Agenda Item # 5

SUB-003660-2026

Resubdivision of Lots 44 & 46, Revised Zeigler Airport Commercial Park Subdivision

APPLICATION NUMBER 5 DATE April 16, 2026

DETAIL SITE PLAN

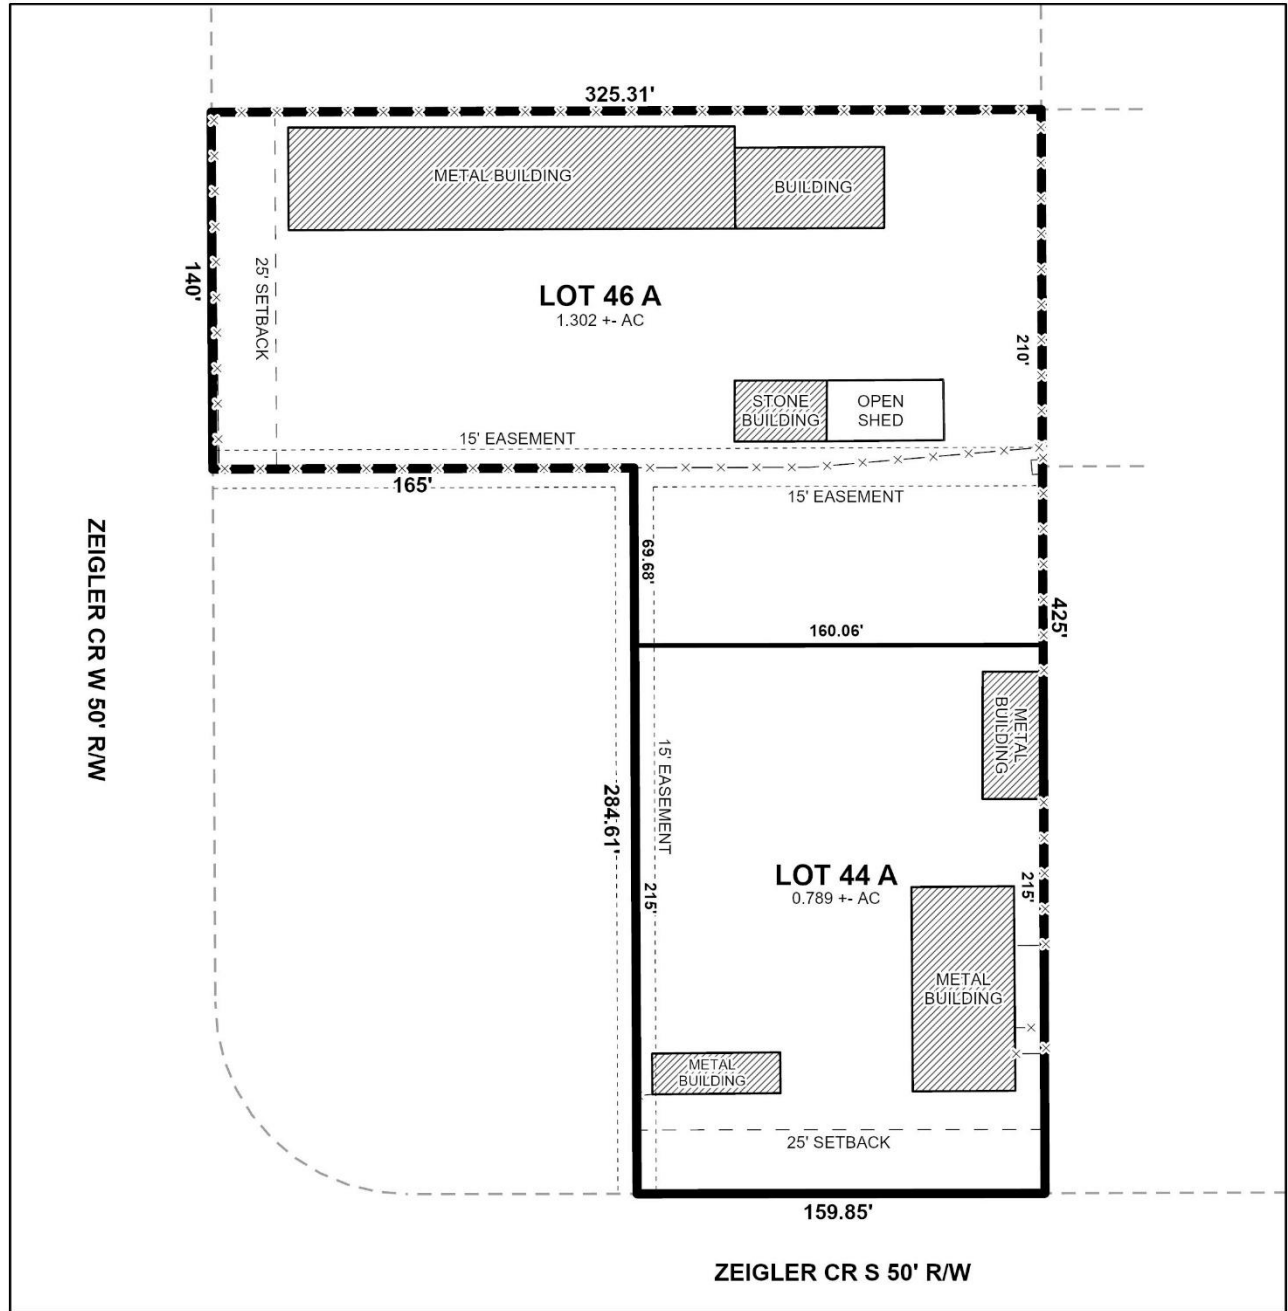
The purpose of this request is to adjust an interior lot line between two (2) legal lots of record. The site is served by public water and sanitary sewer.

Lot 44-A has frontage along Zeigler Circle South, and Lot 46-A has frontage along Zeigler Circle West. Both are minor streets with curb and gutter improvements requiring 50-foot-wide rights-of-way. The preliminary plat depicts sufficient right-of-way widths along both streets; therefore, no additional dedication is required.

Both lots exceed the minimum area requirements of Article 2, Section 64-2-14.E. of the Unified Development Code (UDC) for properties served by public water and sanitary sewer within the B-3, Community Business Suburban District. The preliminary plat properly labels each lot with its area in both square feet and acres. If approved, this information should be retained on the Final Plat; alternatively, a table providing the same information will suffice.

Lot 46-A is technically classified as a flag-shaped lot, which disqualifies the request from Minor Subdivision approval under Section 3.E.9. Subdivision Regulations. Additionally, Section 6.C.9. of the Subdivision Regulations generally discourages flag-shaped lots unless specific hardship or contextual criteria are present (e.g., natural or man-made barriers, unusual lot configuration, disparate uses, or a pattern of irregular lot designs in the vicinity). While these criteria may not be clearly satisfied, the proposed adjustment of the interior lot line does not alter the functional design of either lot in a manner typically associated with concerns over flag-shaped lots—such as creating limited street access via a narrow “pole” or preventing the provision of additional frontage. Instead, the adjustment primarily reduces the area of Lot 44-A without adversely affecting access or development potential. As such, a waiver of Section 6.C.9. may be appropriate.

A 25-foot front yard setback is shown along both street frontages, consistent with Article 2, Section 64-2-14.E. of the UDC and Section 6.C.8. of the Subdivision Regulations. This information should be retained on the Final Plat, if approved.

Multiple drainage and utility easements are depicted on the preliminary plat. Accordingly, Note #8—stating that no structures shall be constructed within any easement without permission from the easement holder—should be retained on the Final Plat, if approved.

1. Retention of the 50-foot-wide rights-of-way along Zeigler Circle South and Zeigler Circle West on the Final Plat;
2. Retention of the lot size labels in both square feet and acres, or the provision of a table on the Final Plat providing the same information;

3. Retention of the 25-foot front yard setback along all street frontages, in compliance with Article 2, Section 64-2-16.E. of the UDC and Section 6.C.8. of the Subdivision Regulations;

4. Retention of a note on the Final Plat stating no structures shall be constructed within any easement without permission from the easement holder;
5. Compliance with all Engineering comments noted in this staff report;
